**Clarification of Scope of Works
For**

RFQ48.2024 – Taylor Park Handrails and Metalwork

Weddin Shire Council

Ramp #4 - no length measurement information on L301

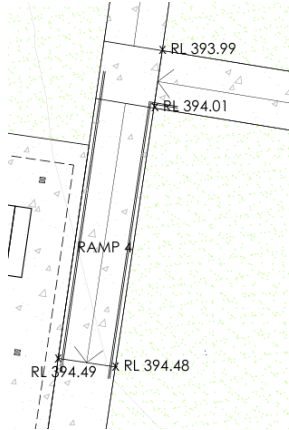
Would you be able to have Sala4D clarify the measurements on the below as there still appears to be missing measurement data on the updated plans from yesterday.

I have brought this to sala4D's attention and they have provided me with updated drawings with these measurements.

These new documents will be added to councils website shortly (25.02.2025).
